Access Compliance Report

Public Rights-of-Way

(Curb Ramps)

Intersection ID: 42943	Main Street: LONG PAW LN	Cross Street: SONOMA VALLEY DR	Location: W
ADA ID: 299E2E560D55	Ramp Type: PerpDiag	Initial Pass/Fail: Fail	Overall Compliance: No
		Severity Score: 10

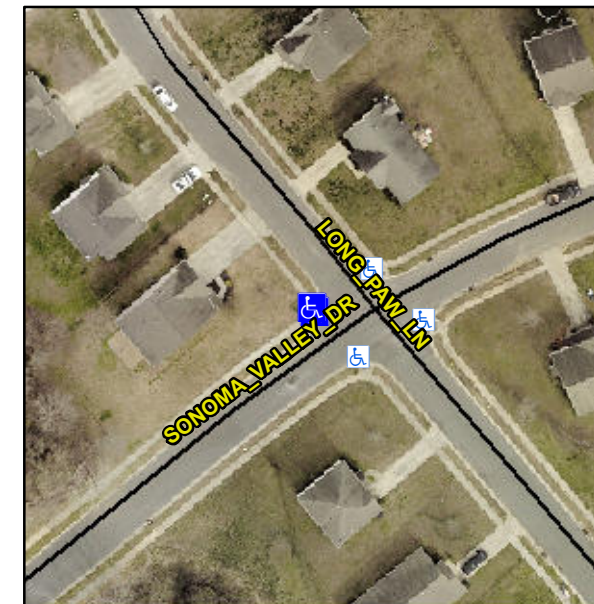
Not Found, R304.5.1, R304.5.3

Compliance	Description	Data	Compliance	Description	Data
N/A	Ramp Length (in)	49.0	Yes	Ramp Slope (%)	7.1
No	Ramp Width (in)	47.0	No	Ramp XSlope (%)	2.6
N/A	Flare Type LT	N/A	N/A	Flare Type RT	N/A
N/A	Flare Slope LT (%)	N/A	N/A	Flare Slope RT (%)	N/A
N/A	Flare Traversable LT?	N/A	N/A	Flare Traversable RT?	N/A
N/A	Landing Length (in)	N/A	N/A	DWS Provided?	N/A
N/A	Landing Width (in)	N/A	N/A	DWS Contrast?	N/A
N/A	Landing Slope (%)	N/A	N/A	DWS Length (in)	N/A
N/A	Landing X Slope (%)	N/A	N/A	DWS Full Width?	N/A
N/A	Landing Curb? (Y/N)	N/A	N/A	DWS Offset (in)	N/A
N/A	Shared Landing?	N/A			
N/A	Gutter Ponding?	N/A	N/A	Gutter Slope (%)	N/A
N/A	Gutter Lip Ht (in)	N/A	N/A	Gutter X Slope (%)	N/A
N/A	Painted X Walk1?	No	N/A	Painted X Walk2?	No
	X Walk 1 Direction	To SE		X Walk 2 Direction	To NE
N/A	X Walk 1 Width (in)	N/A	N/A	X Walk 2 Width (in)	N/A
	X Walk 1 Slope (%)	4.9		X Walk 2 Slope (%)	2.1
	X Walk 1 X Slope (%)	0.9		X Walk 2 X Slope (%)	3.7

Remove & Replace Curb Ramp With Two New Directional Ramps or Equivalent.
